Supplemental Biodiversity Review of Weda Bay Nickel Project

July 2010

Prepared by Scott G. Cardiff¹

Map 2. Areas to be cleared (based on 2007 forest cover map) for mining or potentially for exploration and mining relative to Protection Forest (from overlay of ESIA pp. 122 and 227 and others)

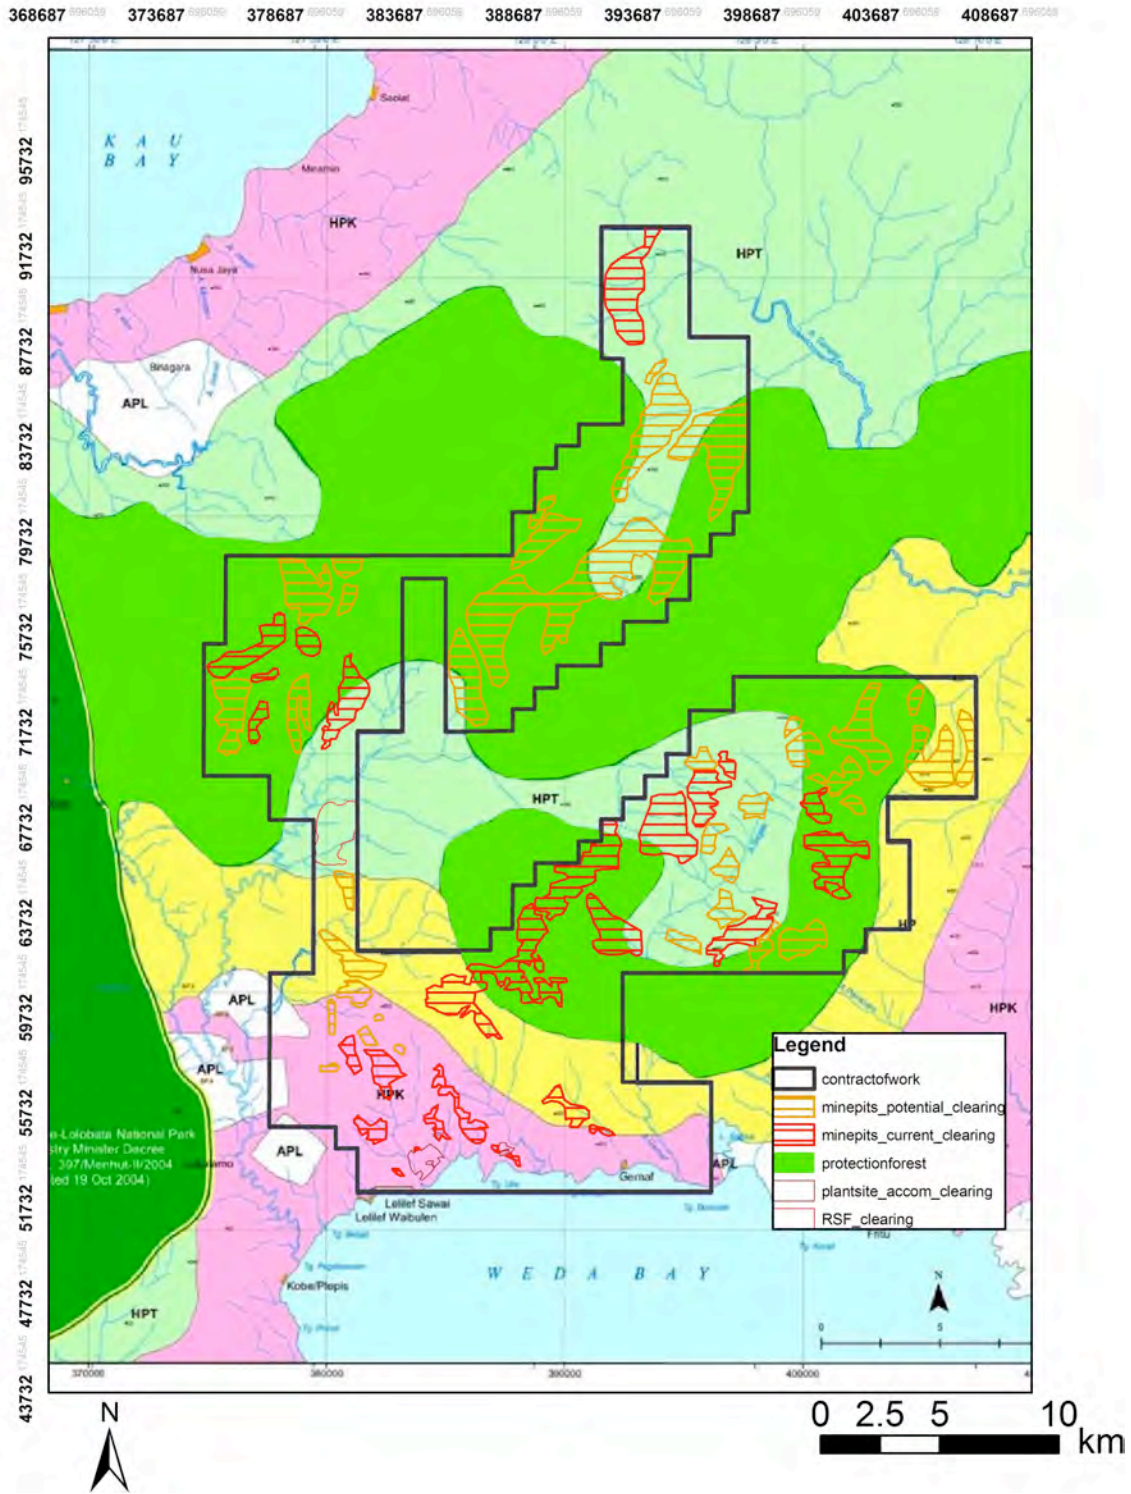
The project documents do not identify the surface area that would be destroyed for mining (for test pit, roads, or mine pits or other facilities) that is in the Protection Forests. From digitizing and overlaying maps in the ESIA and ANDAL it appears that 48 % of the area to become mining pits is in Protection Forests (approximately 2500 ha; see map 2 in Appendix). The ESRS fails to include a map, which would allow for a more informed judgment of forest cover impacts.

without counting roads and influx of other activities), but also the arrangement of those areas to be cleared is such that no large extents of forest will remain as continuous viable habitat corridors (see map 2 in Appendix). The project will remove some of the only Protection Forest on the island that is between the sections of the National Park.⁵

Map 4. Exploration drilling sites relative to Protection Forest (based on ANDAL p. 34 and ESIA p. 227). Drilling sites extend throughout areas to be mined and through large portions of the Protection Forest (light green).

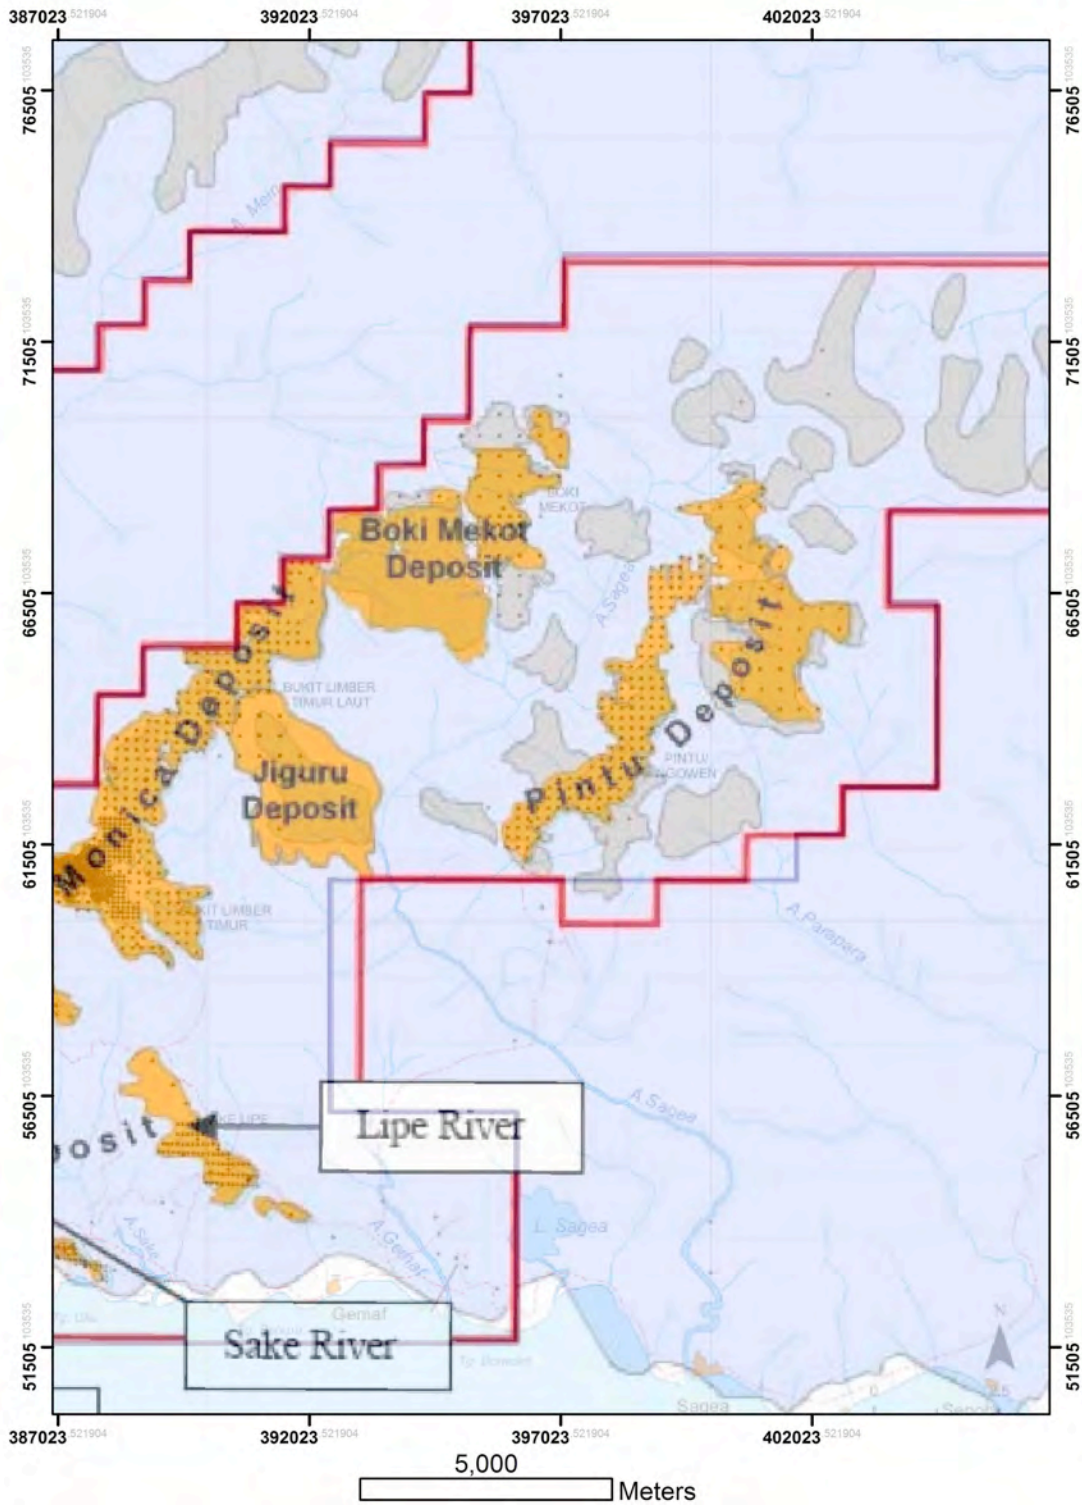
ESRS claims impacts on forests will be small during exploration even though roads could be quite extensive and lead to encroachment of other activities as suggested in the ESRS because of loss of agricultural land (16) and influx of people seeking jobs and other opportunities (17). Exploration has already occurred throughout the main ore deposits (see map 3 in Appendix) but the surface area cleared at each drill site and for transportation between sites and overall forest impacts are not documented (ESIA Appendix A). The potential areas of new exploration are vast and not described but shown on one map (ESIA Appendix A p.4). Much of those additional potential areas are in Protection Forest (map 2 in Appendix). These are impacts that will occur under the Exploration and Feasibility phase as well but are not quantified. In addition, the impacts on forest cover are trivialized even though the exploration drilling has occurred throughout the Protection Forests in the Contract of Work (see map 4 in Appendix). The ESIA claims that the 13 ha forest destruction for the test pit is “very small” relative to remaining lower montane forest on Halmahera but fails to quantify the extent of that remaining forest and fails to account for cumulative impacts of other deforestation activities and of the other planned clearing for mine sites.

Map 5. Location of limestone karst to be quarried relative to river and mangroves (pink; based on ANDAL p. 31 and ESIA p. 175)

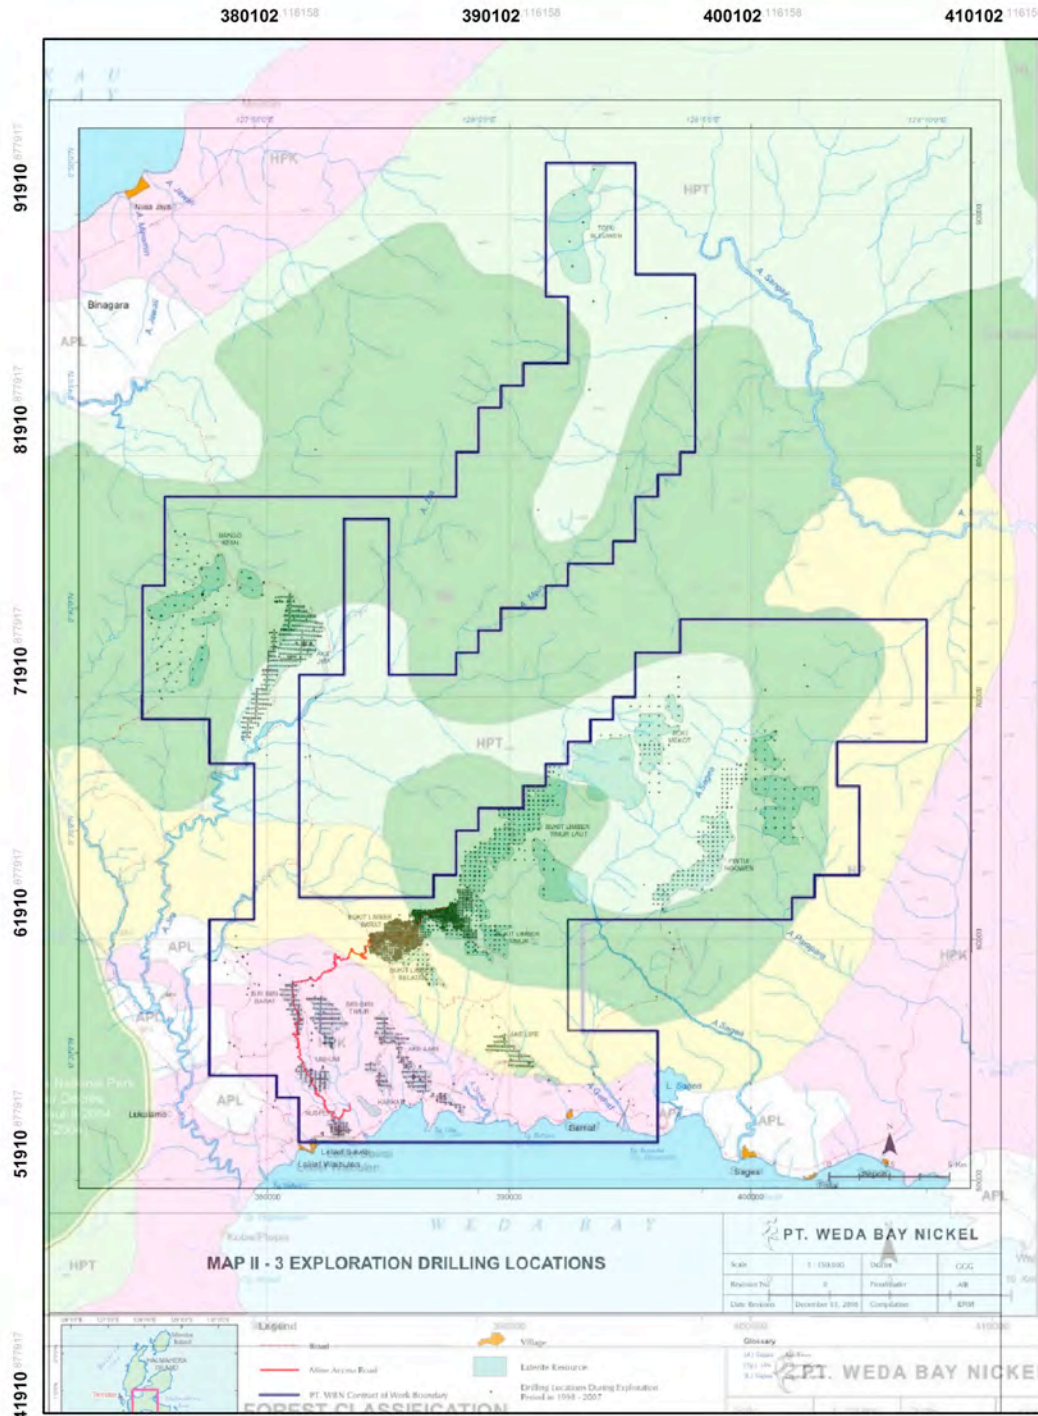
The limestone karst area is a potential important area for water conservation and often for endemic species and for congregatory species (bats). The ANDAL mentions concern for “karst terrain, which is usually considered conservation area” (ANDAL II-74) but this is not discussed in the rest of the project documents.
